## UNITED STATES ENVIRONMENTAL PROTECTION AGENCY REGION IX

Re: Aspire Public School, 1009 66<sup>th</sup> Avenue, Oakland, California – USEPA November 13, 2009 Approval of Polychlorinated Biphenyls' Cleanup Notification Under Toxic Substances Control Act – Request for Cap Modification

Proposed Toxic Substance Control Act (TSCA) Cap for Modular Buildings – Former Pacific Electric Motors Facility, 1009 66th Avenue, Oakland, California

Figure 3 - Rat Slab Design (hand drawn map)

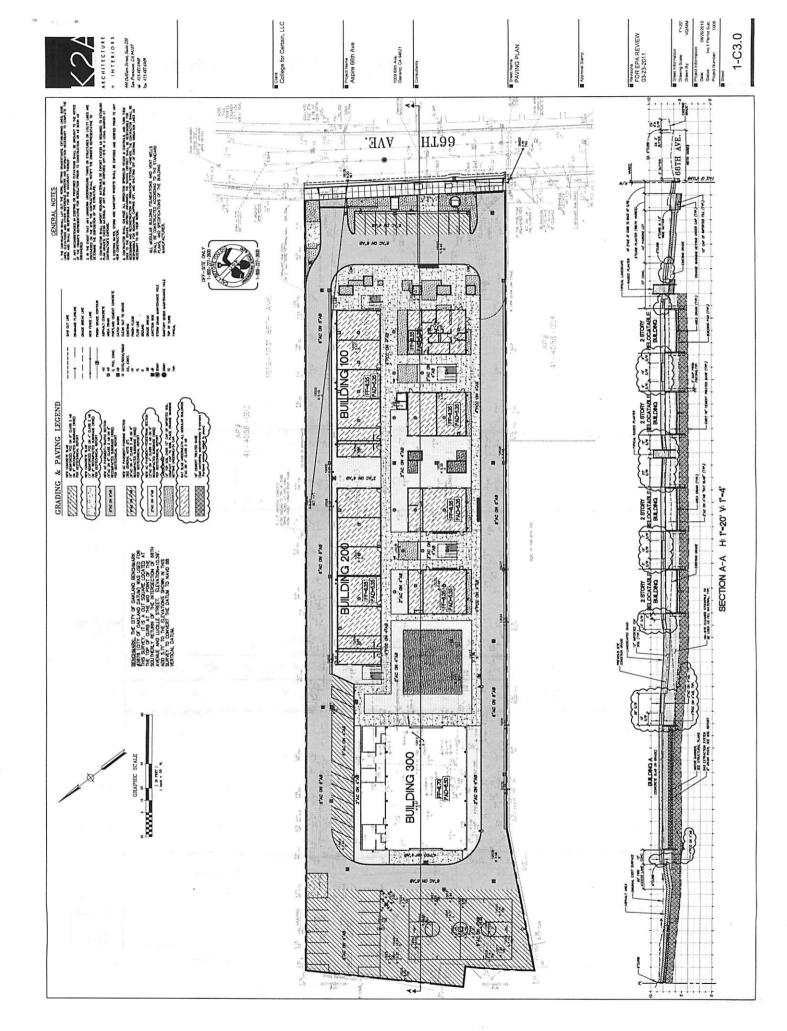
In the attached letter, Arcadis is proposing a modified design for the rat slabs over which the schools modular buildings will be installed. These modified rat slabs are proposed as an alternate cap design for the portion of the site where the modular buildings will be located and such proposed cap differs from the concrete cap required in 40 CFR 761.61(a)(7). The proposed alternate cap (modified rat slab) is a 6-inch-layered cap that will be constructed atop 18-inches of cement-treated native soil contaminated with residual PCB levels. The 18-inch soil layer is underlain by native soils. The proposed alternate cap consists of a 4-inch thick layer of imported base rock atop the 18-inch cement treated soils and a 2-inch thick Portland cement concrete layer atop the base rock layer.

We are approving the proposed design for the alternate cap (modified rat slab) under the TSCA regulations in 40 CFR 761.61(c) (risk-based cleanup option). We believe this alternate cap is still protective of human health and the environment provided that required maintenance and repairs are conducted as required in Condition 9 of the November 13, 2009 approval. The rat slab is a portion of the site-wide cap required for the Aspire site in USEPA's November 13, 2009 conditional approval of the October 23, 2009 Notification of PCB cleanup at the Aspire site. This approval modifies a portion of the site-wide cap required in Condition 8 of USEPA's November 13, 2009 letter. This approval does not modify Condition 9 in USEPA's November 13, 2009 Notification approval that requires maintenance and repair of the cap in perpetuity. The requirements in Condition 9 are equivalent and consistent with the requirements in 40 CFR 761.61(a)(8).

- Native soil
- 18 Inches of cement treated native soil
- 4- Inches of imported aggregate base rock and
- 2- Inches of Portland cement concrete
